CPM - Microcontroller

Adam Davis

Version II considerations

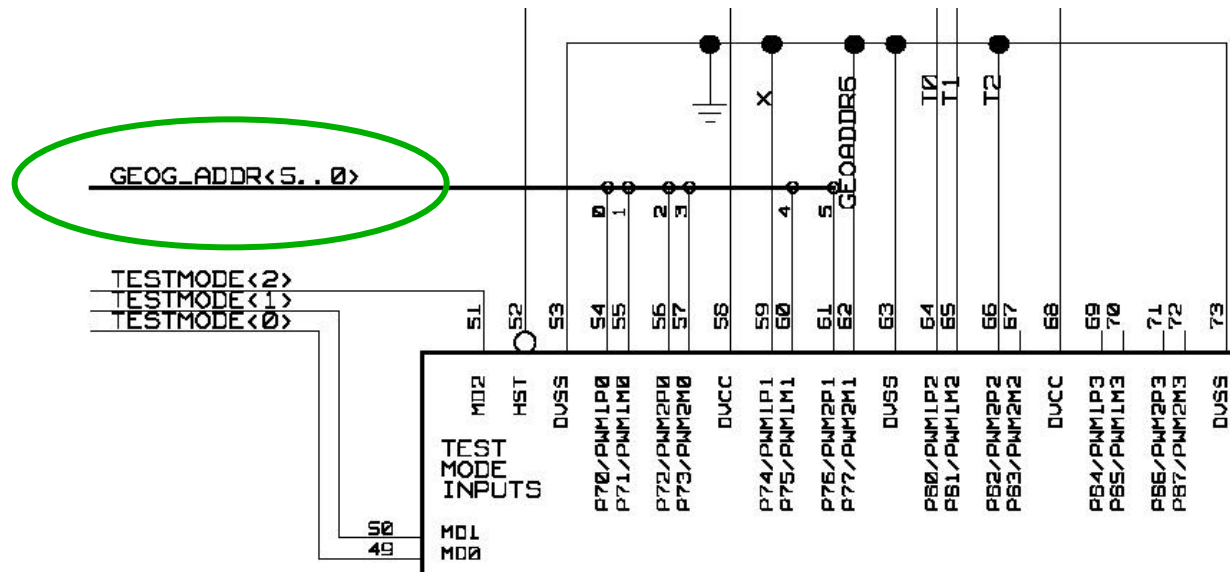
- What I can't do.
 - Cannot read GEO_ADDR(5..0) - Buffer these to 5V CMOS

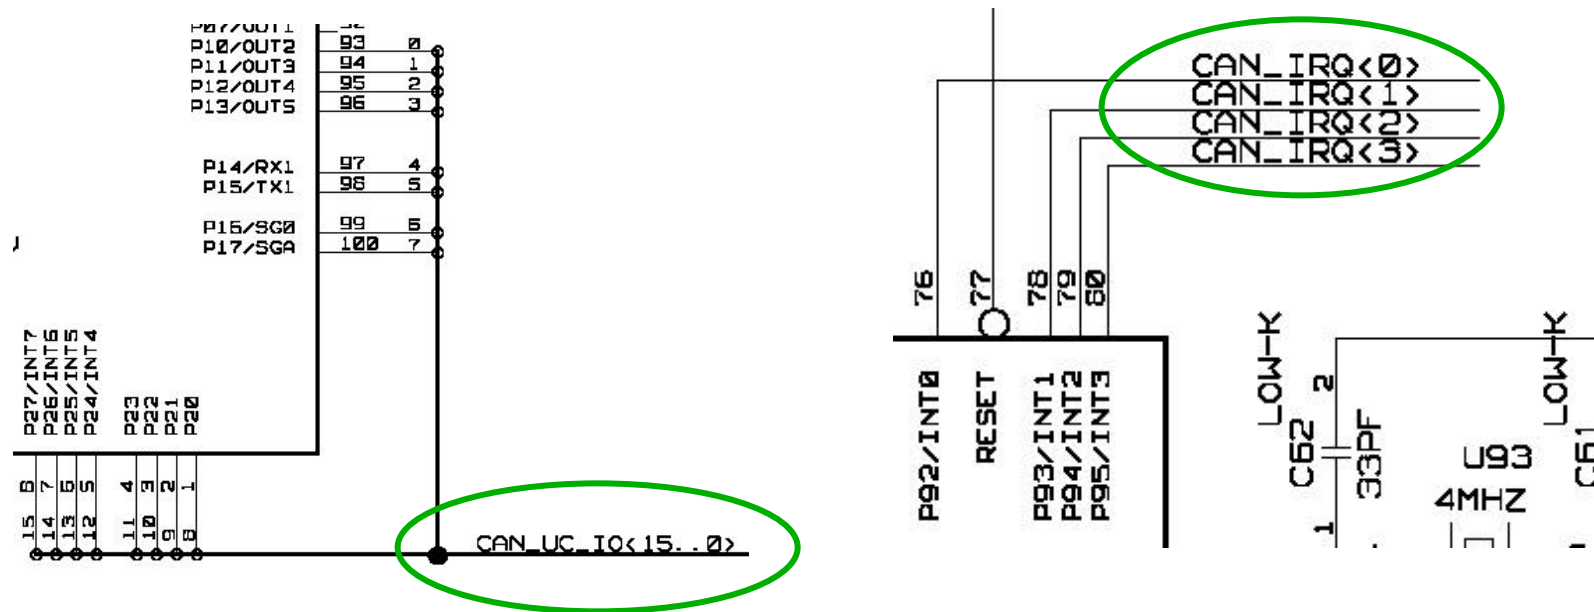
- Think this will also include the nets: -
 - CAN_UC_IO(15..0)
 - CAN_IRQ(3..0)
